9111 CYPRESS WATERS  
LOUNGE & CONFERENCE  
RENOVATION

NO.	REVISIONS:	DATE:
1	PR #1	06/05/24

LEVEL 01  
MECHANICAL PLAN

**M2.01**

**1 LEVEL 01 MECHANICAL PLAN**  
SCALE: 1/8"=1'-0"

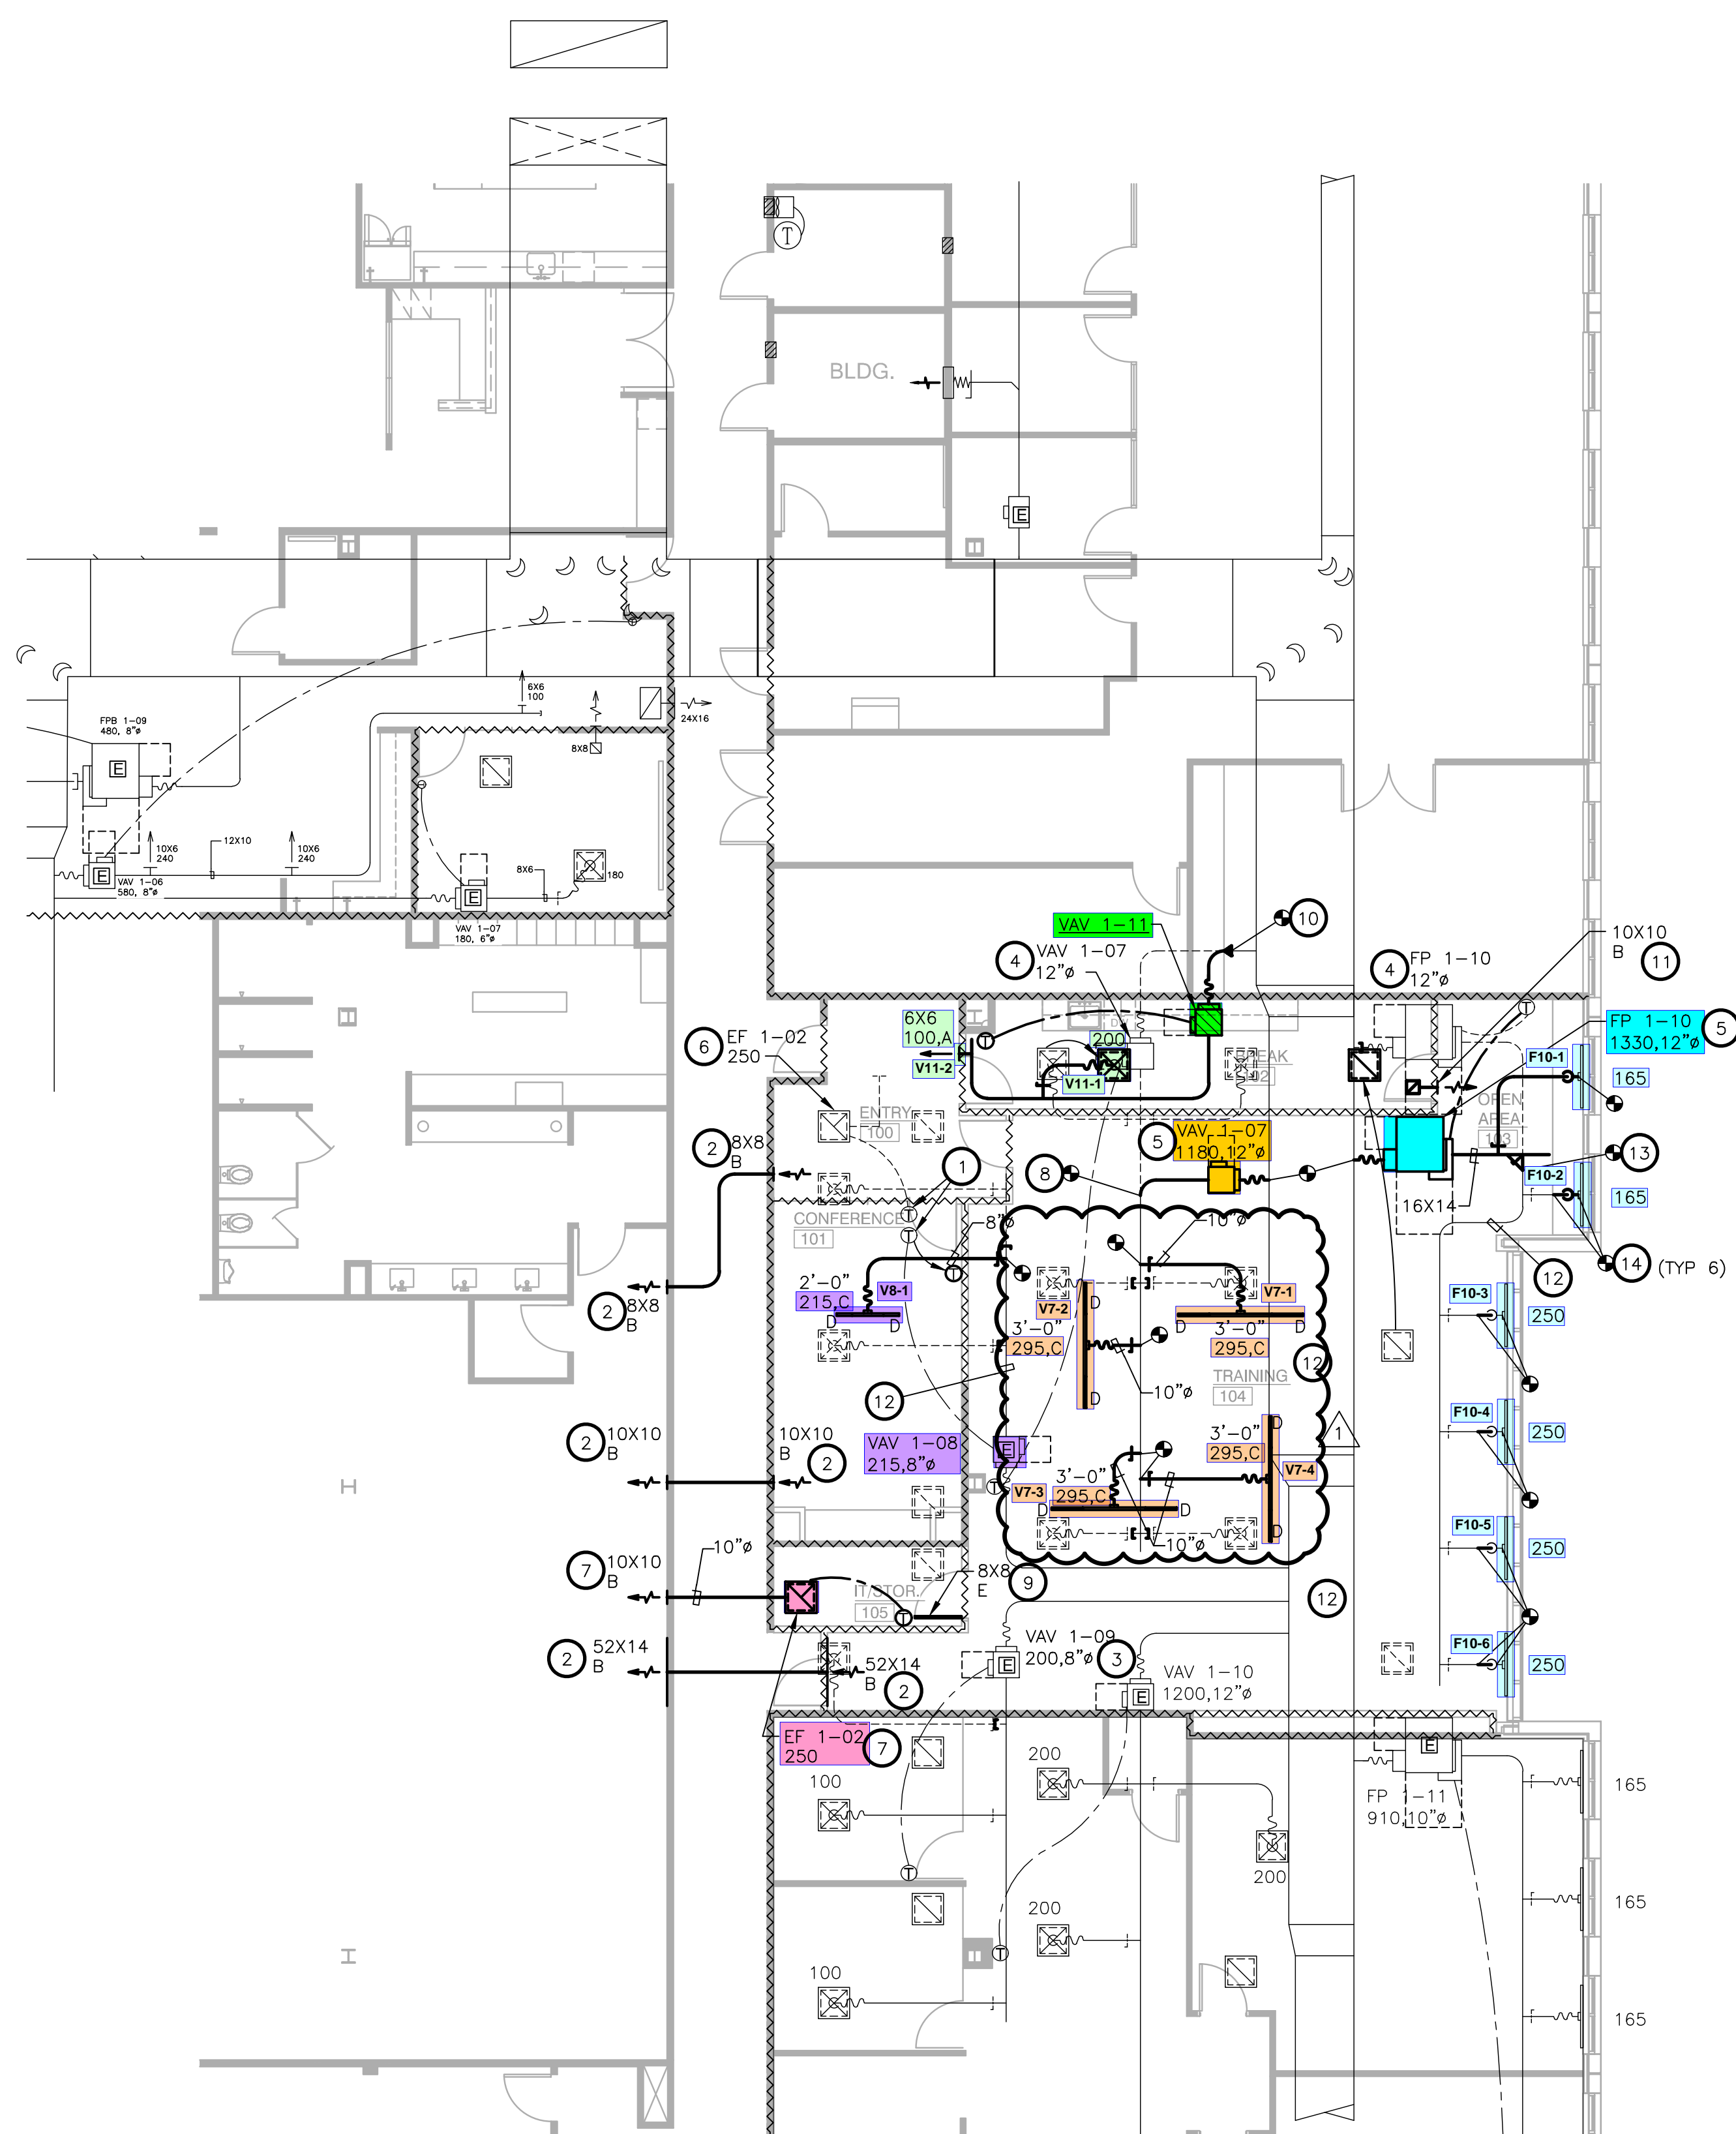
REVISION SUMMARY:  
• MOVED SLOT DIFFUSERS PER NEW RCP.
